CITY OF ALBUQUERQUE

RE: **Rohan Subdivision**
Lots 3 – 4
Requested for Pad Cert – Not Accepted
Engineers Stamp Date 6/29/15 (C19D042A)
Certification dated: 3-6-19

**LOTS 1 THRU 4, ROHAN SUBDIVISION
GRADING AND DRAINAGE PLAN**

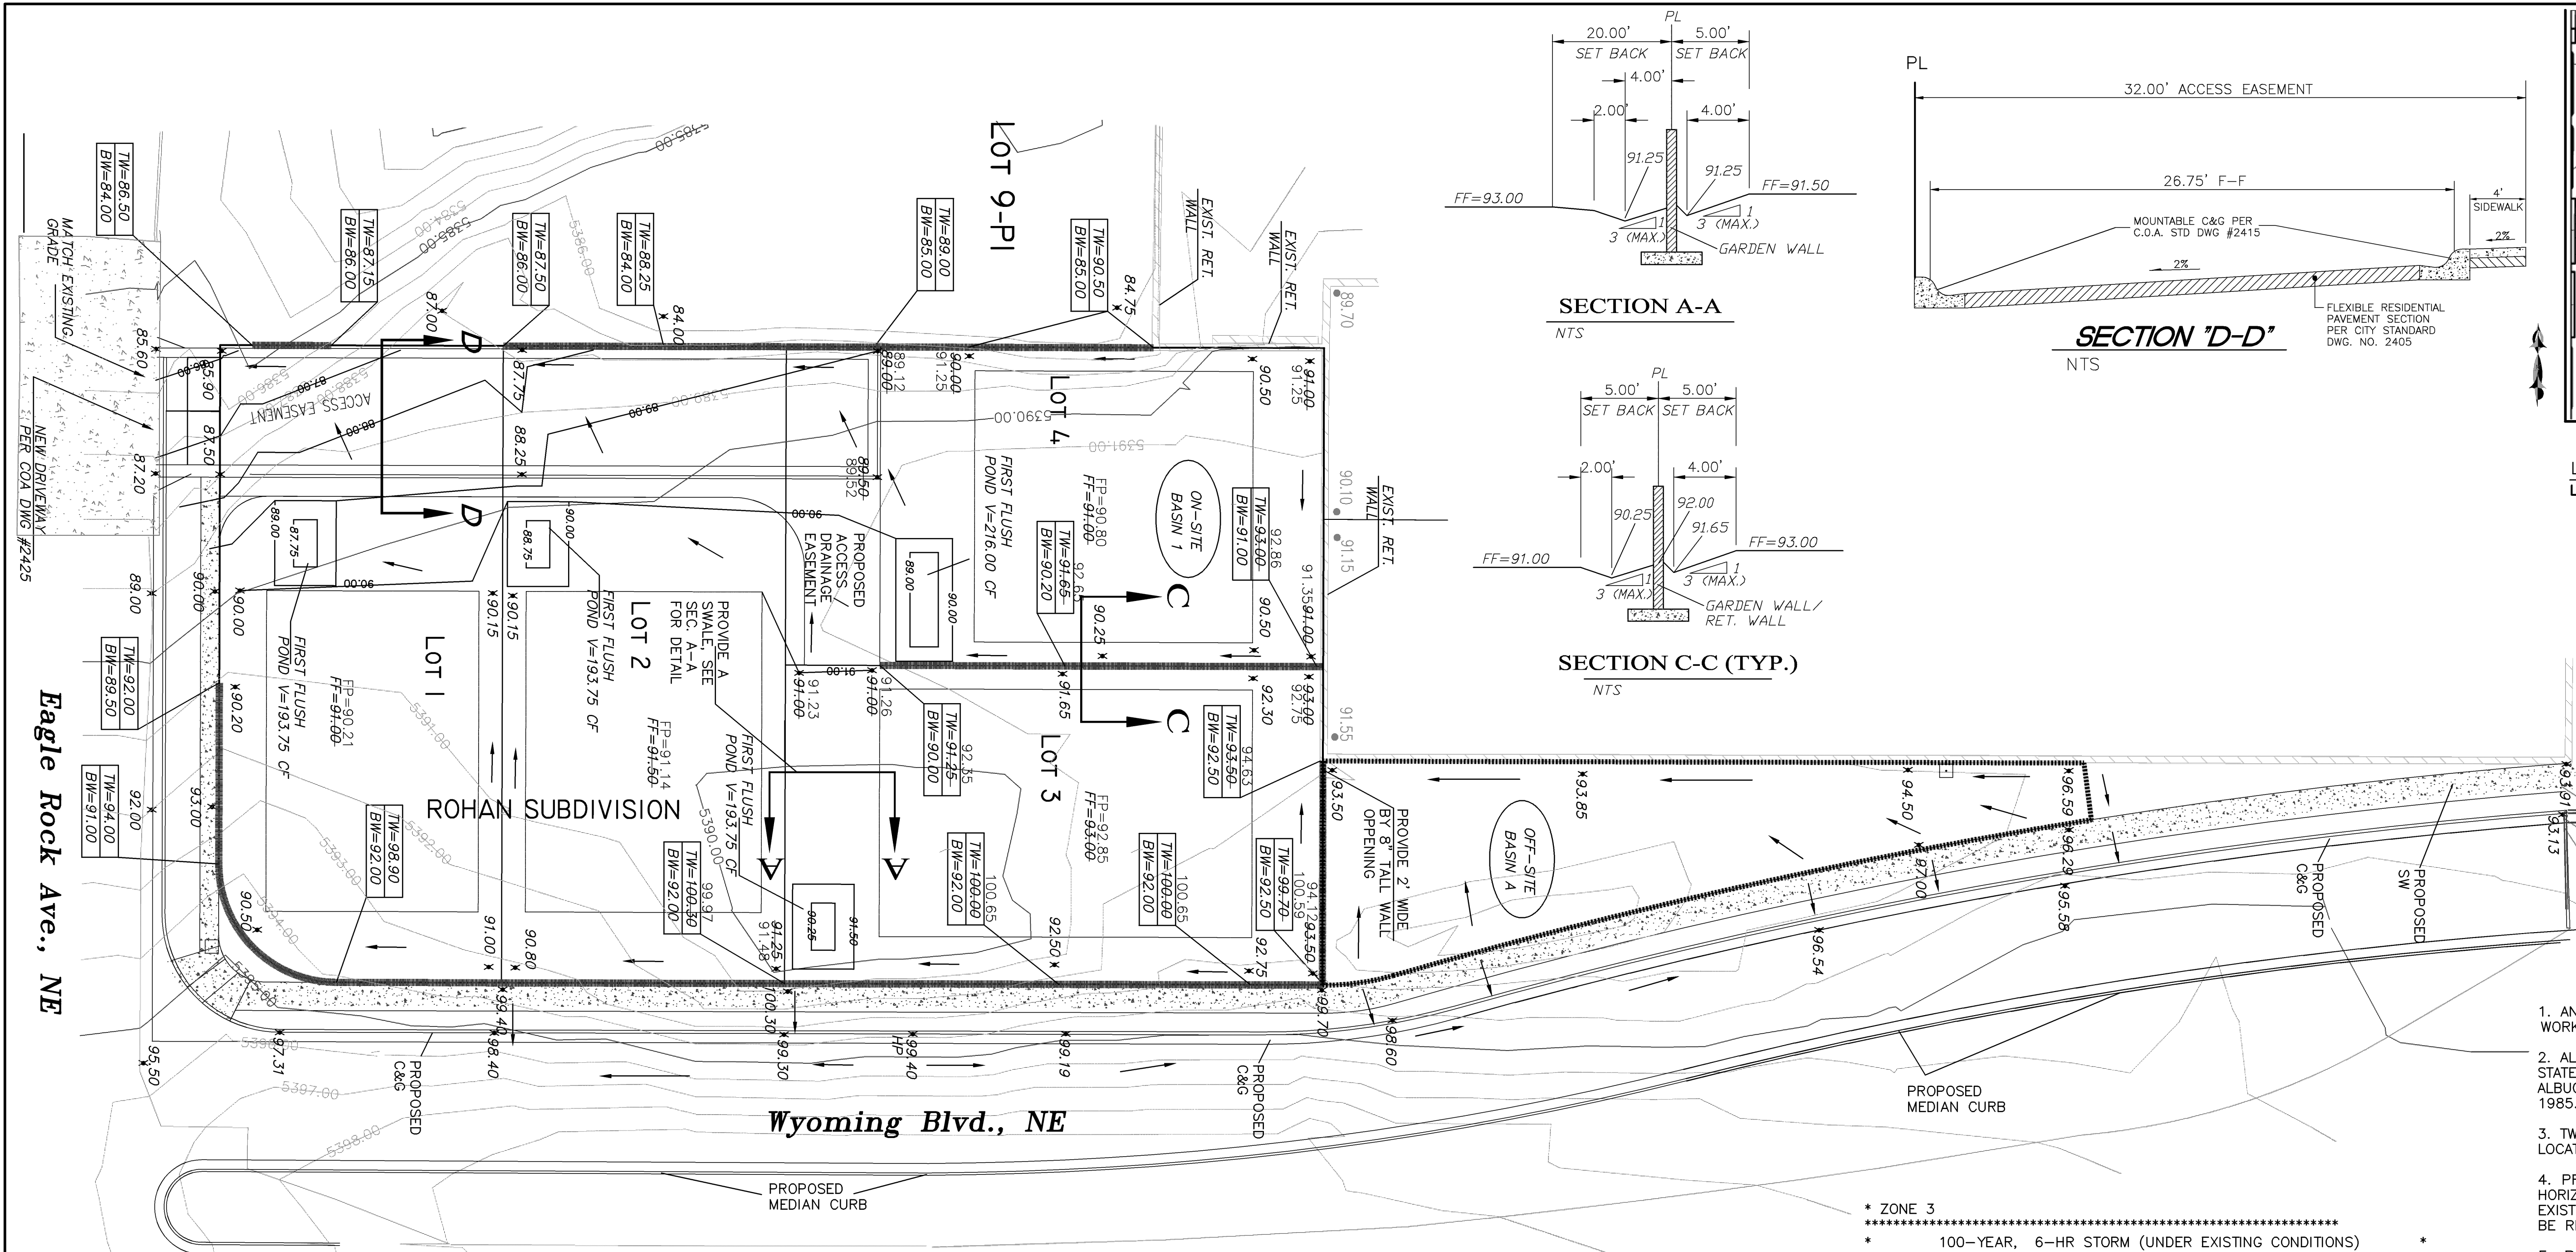
- Wall opening lot 3 is different than on plan. Clarify in certification that smaller opening is sufficient.
- Swales on both sides of garden wall (section A-A) between lots 2 and 3 are missing.
- Ponds are missing on lot 3 and 4.
- Provide request for Release of Financial Guarantee
